TECHNICAL INFORMATION

No: 76/18/99/NAS
Ref:
Issue: 1
Date: 06/18/99

Rattle In Center Console

Discovery Series II (LT)

Figure 1

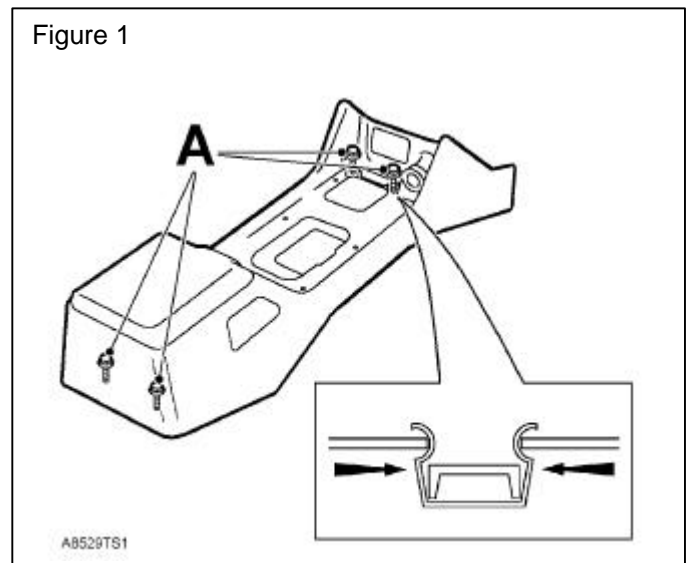
1. Refer to WSM 76.25.01 and remove center console.
2. Replace each cage nut as follows:
 - Compress side retainer clips of original cage nut. (Figure 1)
 - Remove and discard cage nut.
 - Install new cage nut (NK106061L) into bracket opening.
3. When all four cage nuts are replaced, refer to WSM 76.25.01 and install center console.
